TT113 Mechanical Repairs
Marine Corps Base, Camp Lejeune, NC

Structural Interior Design Package
Final Submittal
June 2025

Project: TT113 Mechanical Repairs
Meeting: 35% Review Meeting
Date: December 19th, 2024
Location: Public Works at MCB Camp Lejeune, NC

Project: TT113 Mechanical Repairs
Meeting: 65% Review Meeting
Date: March 11th, 2025
Location: Public Works at MCB Camp Lejeune, NC

A1 FINISH PLAN

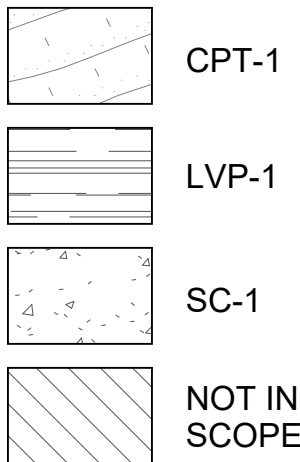
Item #8 I-111: I suggest keeping 1 carpet type, 1 LVT type, and 1 or two tile types depending on use. Makes it easier for replacement later on and cost savings.

Item #17 I-111: The Family Care Program Team felt that LVT-1 and LVT-2 would ALL be the same, not 2 styles/looks.

Whether or not combined, could Rm 123 Storage LVT be the same as corridor LVT

Item #18 I-111: They thought the front Vestibule and Rm 117 Resource/Referral would also be LVT (not CPT-1).

Item #1 I-111: Wondering if we should show the finishes by phases so the contractor expects the installers to come back for each phase.

Item #7 I-111 & I-601: Is it LVT-1 (Tile) or LVP-(Plank/wood look)? CDC says it looks like wood, so shouldn't it say "LVP-1"?

Response: Concur.

Response: Concur. LVT will be the same throughout

Response: Concur on Rm 117. However, the entry vestibule is actually showing CPT2 which is a walk-off carpet. Please confirm if you'd still like us to change Vestibule 115 to LVT.

Activity confirmed walk-off carpet is acceptable in Vestibule 115.

MBF agreed this can be sorted out separately – Will discuss in more detail during SID finishes presentation to the Activity.

Response: Concur.

B1 FINGER PINCH GUARD DETAIL
SCALE: 3" = 1'-0"

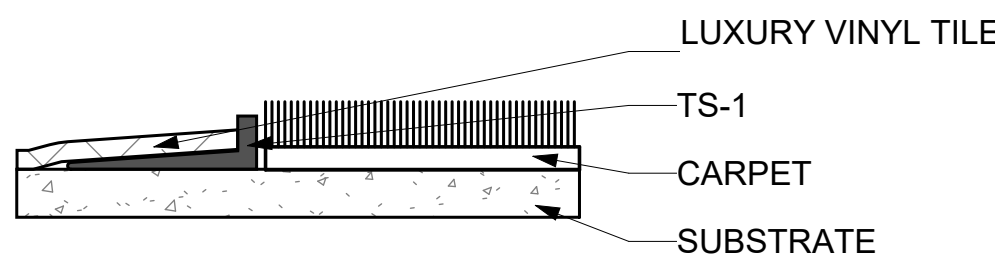
Item #19 I-602: I didn't see "Finger Pinch" guards for doors listed anywhere. Maybe they're already in place.

Item #8 I-601: I didn't see "Finger Pinch" guards for doors listed anywhere. Maybe they're already in place.

Response: Concur. Finger pinch guards will be added to the finish legend and the Wall & Door Protection spec (10 26 00).

Response: Concur. This has been added to the finish legend as "HW-2".
